**PLANNING DIVISION REPORT
DEPARTMENT OF PLANNING AND COMMUNITY
AND ECONOMIC DEVELOPMENT
October 3, 2008**

RE: I.D. #12152, Conditional Use Permit – 637 South Shore Drive

Re: Additional comments regarding conditional use application for a new garage at 637 South Shore Drive

Font Elevation

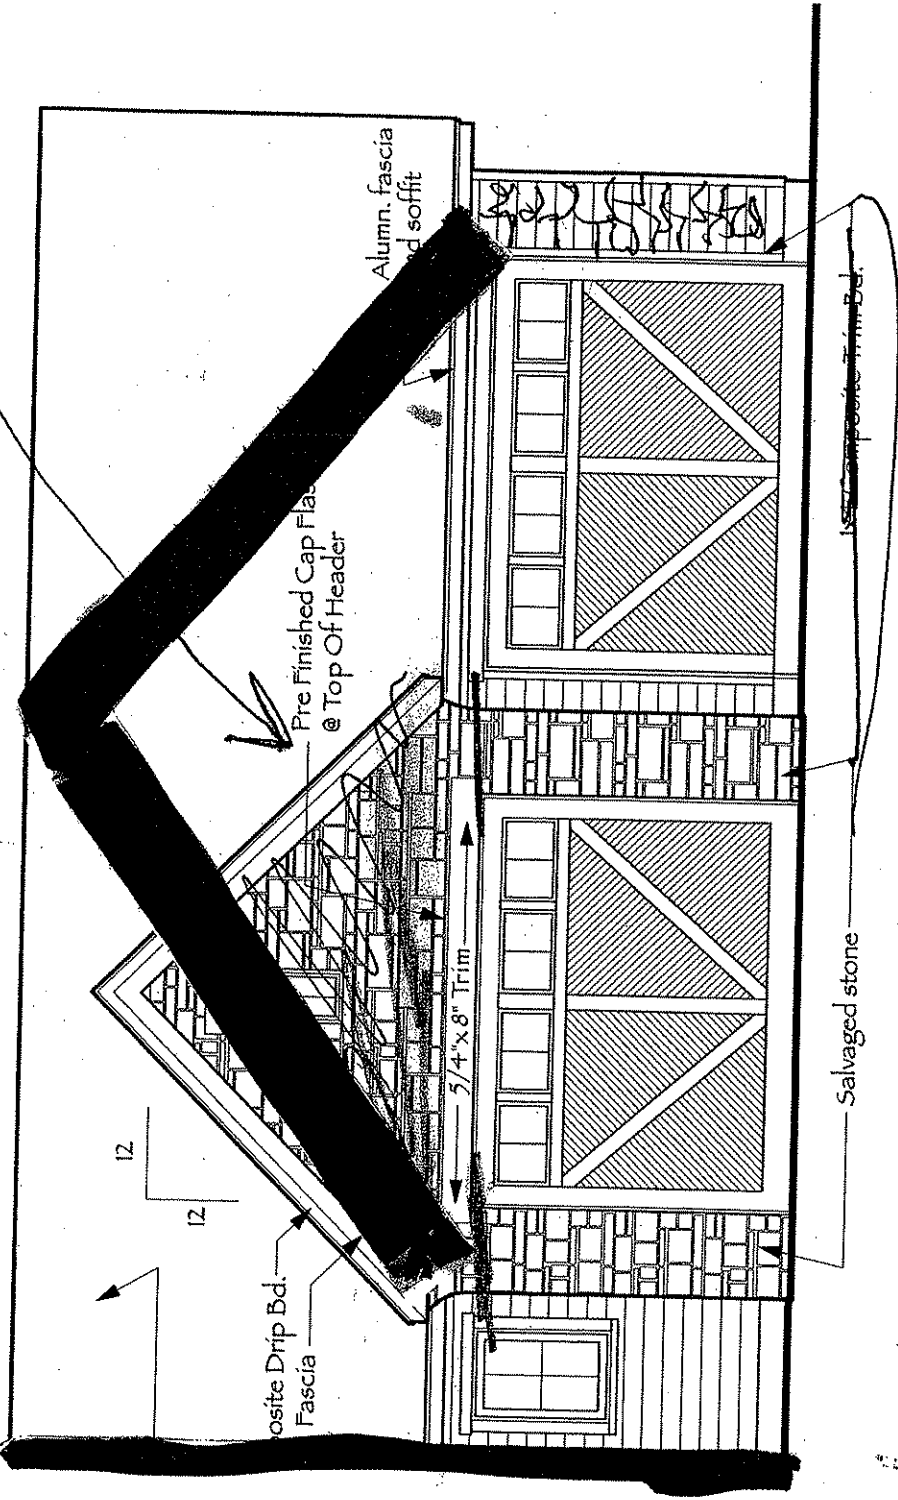
- First, an alternative design concept provided to the applicant by neighbors who were concerned that the design of the proposed garage is too fancy for the neighborhood
- Second, a letter from the architect to the neighbors responding to their concerns
- Third, a follow up letter from the applicant to neighbors responding to their concerns

Concern #1: The design does not fit the character of the neighborhood

I think this concern arises out of the fact that the Alexander property, which has a Tudor design, backs up to 638 W. Lakeside, which is an attractive Arts and Crafts Bungalow. Any Tudor home is going to appear more stylistic than that of a modern take on a Bungalow. However due to the eclectic nature of your neighborhood, if you look at other houses within sight you'll see a number of design characteristics similar to what I've incorporated into this garage:

Concern #2: The design is too fancy.

I considered the suggestion of using my initial design but cutting it off at 30' and enlarging the gable to cover both garage doors. This would be one way to make it appear closer to the Bungalow garage next to it. I have three concerns re: this idea:

■ Architecturally, it's not the best solution because the slope of the gable would require the peak to rise higher than the roof, higher than code. Otherwise the 2nd floor storage area would be so flat that one could not safely stand up in it, which would prevent one from carrying lawn furniture, etc. up into it.

Numerous houses have the Found du Lac limestone used on the Alexander home. My current design for their garage, smaller than the initial, uses more of this stone due to structural aspects of its non-symmetrical shape. There is a flow of the stone up around the garage door that is not broken by any element in the architecture. To stop it suddenly when level with the doors would suggest that they are pillars when in actuality they are not. The effect would be quite awkward and seem to just have a splash of stone just for the sake of having it.
